AIRWORTHINESS DIRECTIVE

CF-2023-46

Navigation – Aeroplane – Prohibition of Operations Requiring Radio Altimeter When Operating in the Contiguous United States due to 5G C-Band Wireless Broadband Interference

Supersedes AD CF-2021-52, issued 24 December 2021.

Figure 1 - Fundamental Effective Isotropic PSD at Outside Interface of Aircraft Antenna

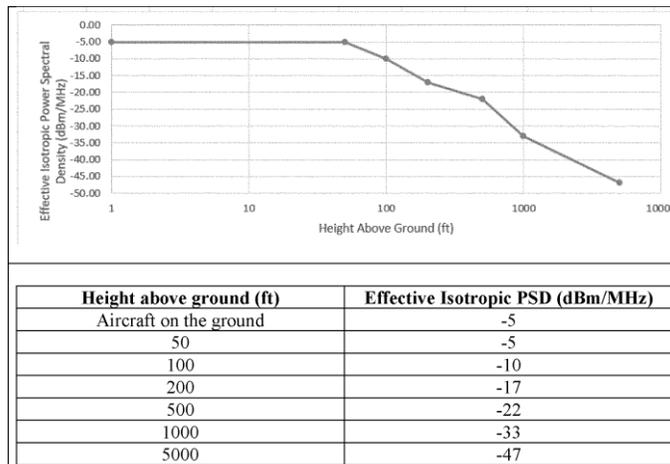
- A. A **radio altimeter tolerant aeroplane** is one for which the radio altimeter, as installed, demonstrates the tolerances specified in Part I paragraphs A.1 and A.2. of this AD, using a method approved by the FAA or Transport Canada. No actions are required by this AD for radio altimeter tolerant aeroplanes.
 - 1. Tolerance to radio altimeter interference, for the fundamental emissions (3.7–3.98 GHz), at or above the power spectral density (PSD) curve threshold specified in Figure 1 of this AD.
 - 2. Tolerance to radio altimeter interference, for the spurious emissions (4.2–4.4 GHz), at or above the PSD curve threshold specified in Figure 2 of this AD.
- B. A **non-radio altimeter tolerant aeroplane** is one for which the radio altimeter, as installed, does not demonstrate the tolerances specified in Part I paragraphs A.1. and A.2. of this AD.
